SALEM COUNTY IMPROVEMENT AUTHORITY

RESOLUTION 2020-93

**A RESOLUTION AUTHORIZING CHANGE ORDER #2 TO THE CONTRACT  
FOR CONSTRUCTION AND INSTALLATION  
OF EXPANSION OF THE METHANE GAS COLLECTION SYSTEM**

# Work Change Directive

NEW HDPE LATERAL TO RESTORE VACUUM TO EXISTING WELLS

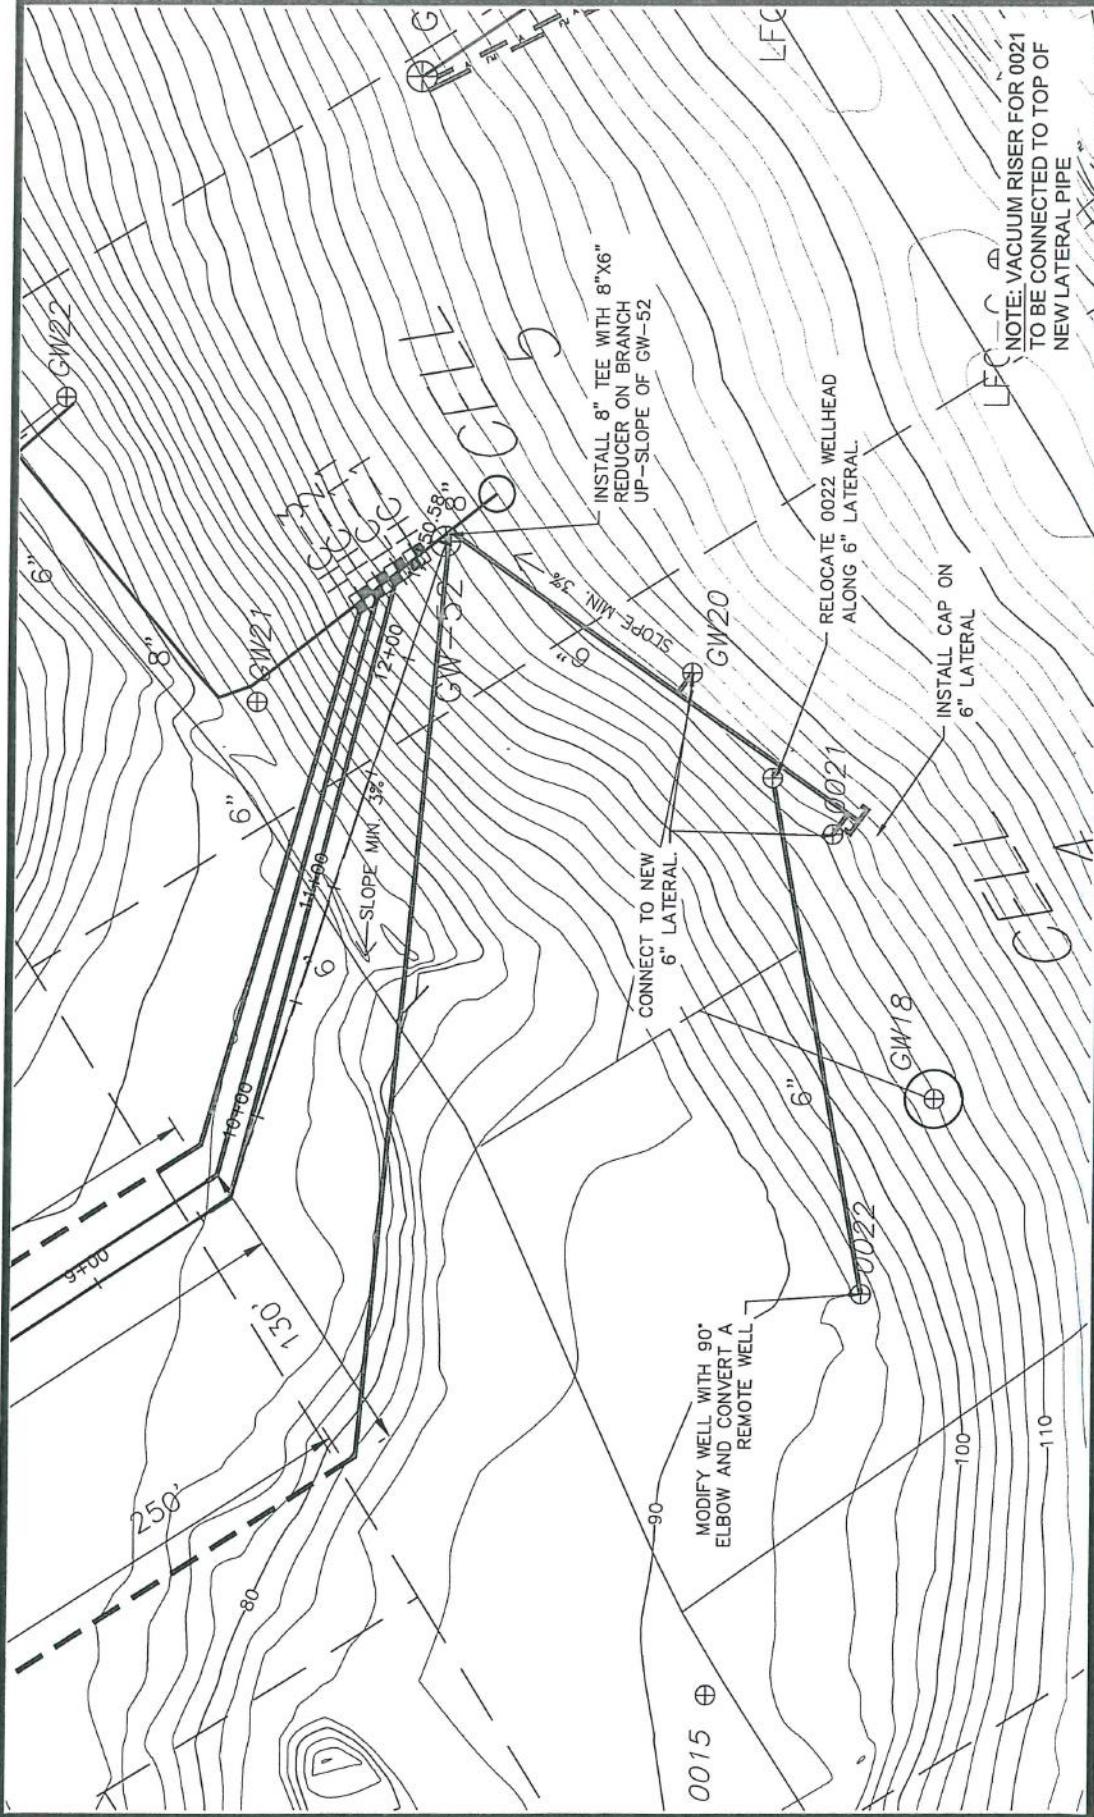
Item No.	Description
WCD 2	1. Install 425' of new 6" HDPE pipe below grade to connect 3 existing Gas wells per the contract unit rate for Contractor supplied 6-inch pipe. 2. Relocate wellhead for existing well 0022 to convert to a remote well
